RE: RMI Middle Mesa Evaporation Facility Permit Application

In response to our recent discussions, and at the request of Mr. Chavez, Mr. Foust, and yourself, RMI would herein amend our permit application to include the following provisions.

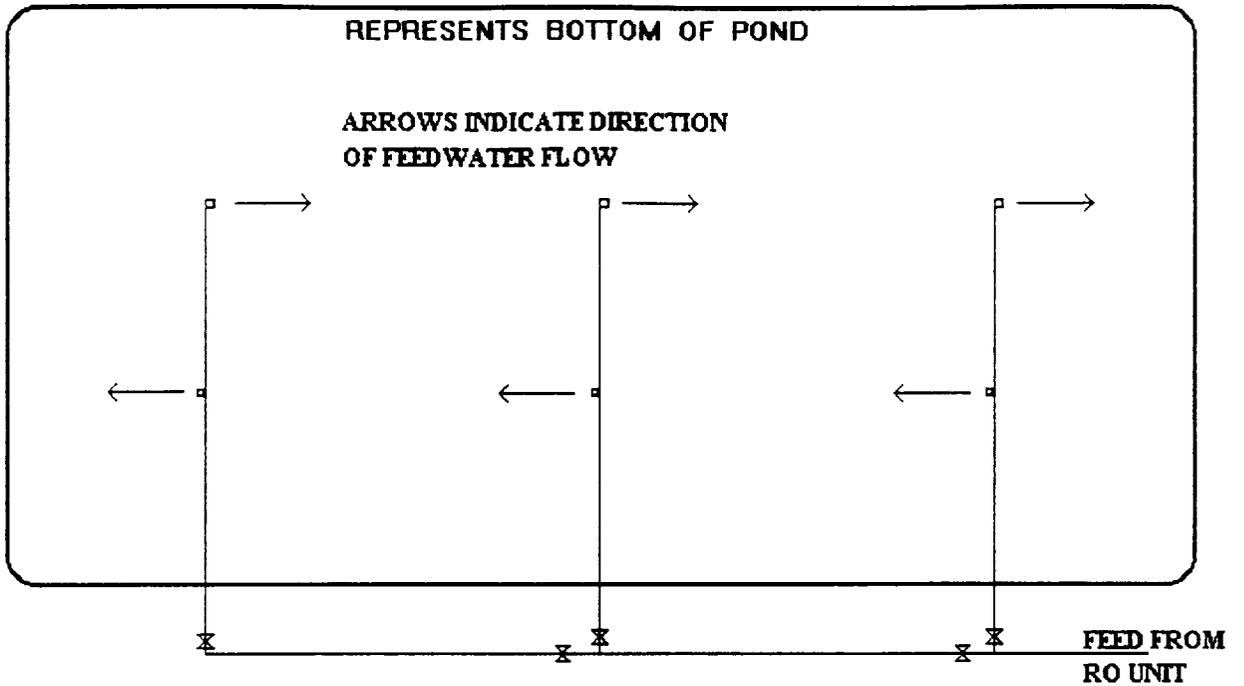
- 1) In order to prevent the occurrence of H₂S and the development of an anaerobic zone in the bottom of the ponds, RMI will construct the inlet feed flow system into the ponds according to the attached diagram.

This design will provide isothermal de-stabilization, enhanced circulation, and continuous oxygenation from the pond bottom to the water surface. The warm water temperature will prevent cold isothermal zones from forming which result in seasonal stagnation of impounded waters. The system will create circulation currents and the dissolved oxygen levels of the inlet water will introduce O₂ into the bottom of the pond. Also, in the unlikely event that H₂S does occur, a dissolved oxygen injection cell can be added to the inlet flow system to remediate the problem.

**LEAK DETECTION SYSTEM COLLECTION HEADERS
1% SLOPE TO HEADERS**

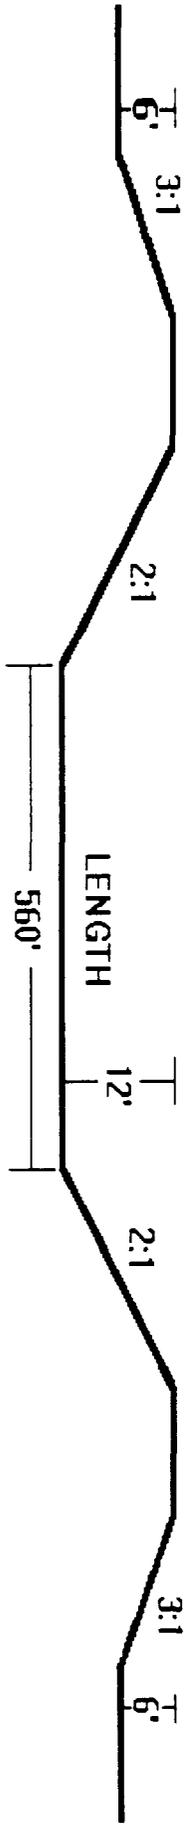
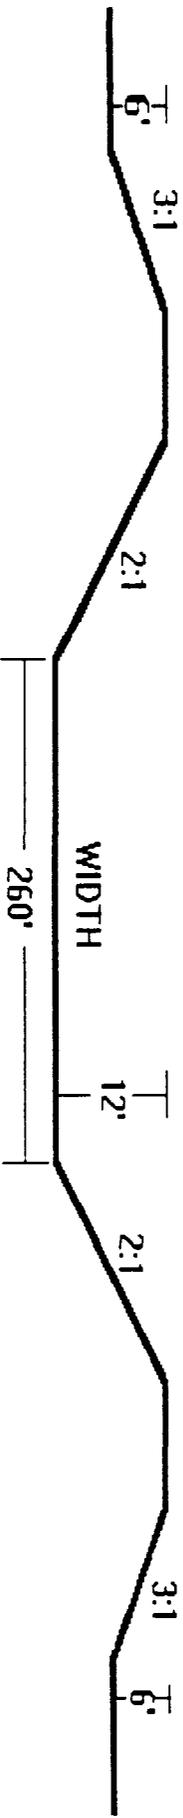
- 7) Also, enclosed herein is a new diagram depicting the revised leak detection design as discussed in our meetings. This design will provide valuable information and expedite RMI's remediation process in the unlikely event of a primary liner leak. The highly permeable PN-3000 geonet will be utilized in combination with the three cell layout resulting in a more immediate detection, and response, to any liner leaks.
